Work Order ID 129726**129726***

Item Name: Quick Release Heli-Utility-Basket™ Long, HD Lid, Spacepod™/Squirrel Cheek Comp.

DART SERVICE INSTRUCTION

TO AMEND INSTALLATION INSTRUCTIONS D350-607-3 Rev.D,
INSTALLATION INSTRUCTIONS D350-607-4 Rev. C AND
INSTRUCTIONS FOR CONTINUED AIRWORTHINESS ICA-D350-607 REV. 6
REF TCCA STC: SH94-14
REF FAA STC: SR00213NY
REF EASA STC: EASA.10016996
REF BRAZILIAN STC: 2007S03-03/-04/-05/-06

FIGURE 1: INSTALLATION OF D4775-041 FWD STRUT

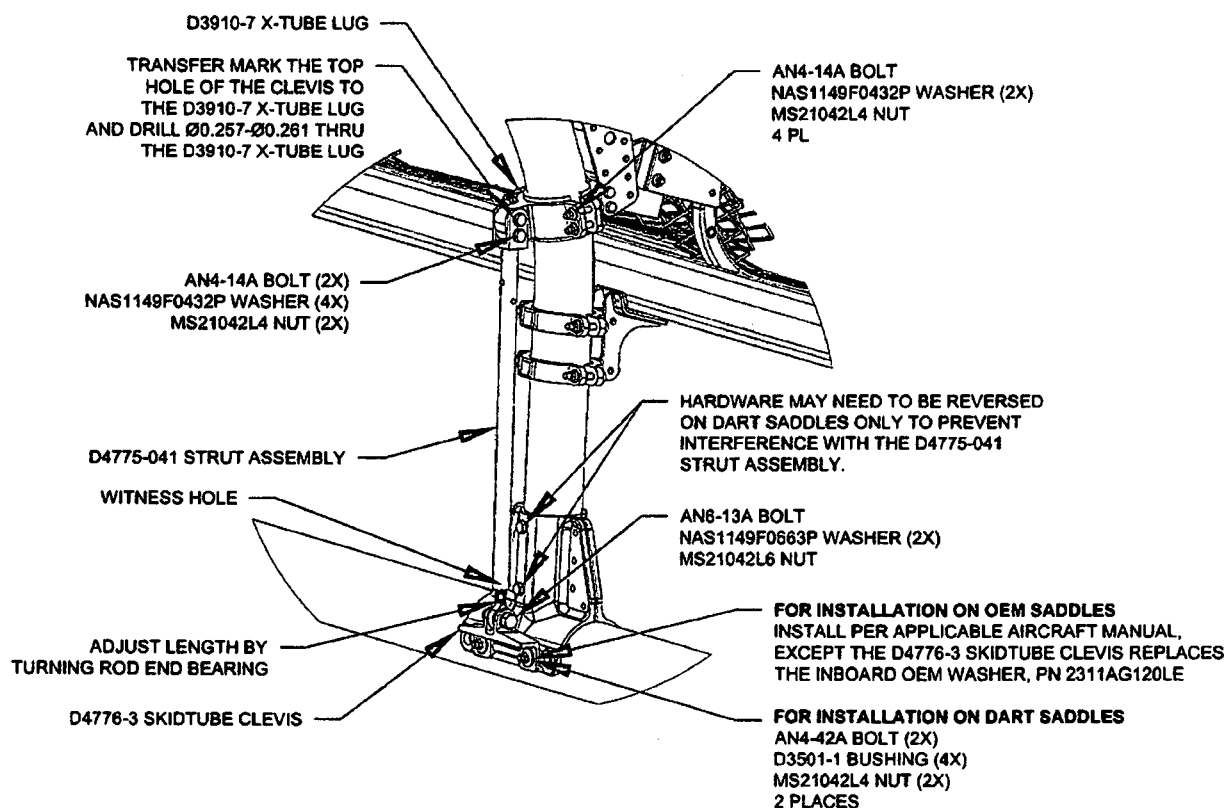
- 3.1 Substitute the Forward Lower D3910-5 X-Tube Lug with the D3910-7 X-Tube Lug as shown in Figure 1.
- 3.2 Install the forward D4775-041 Strut Assembly. Transfer mark from the upper hole on the clevis of the D4775-041 Strut Assembly to the D3910-7 X-tube Lug and drill thru the lug $\varnothing 0.257$ - $\varnothing 0.261$ as shown in Figure 1. Touch up chemical conversion coating per MIL-DTL-5541. Check the witness holes located at the bottom end of the D4775-041 Strut Assemblies to ensure that the thread from the rod end extends past the witness hole.
Torque MS21042L4/-4 nuts to 50-70 in-lbs (5.7-7.9 N-m). Torque MS21042L6/-6 nuts to 160-190 in-lbs (18.1-21.5 N-m).
- 3.3 Complete the installation in accordance with Installation Instructions D350-607-3 Rev. D or D350-607-4 Rev. C.
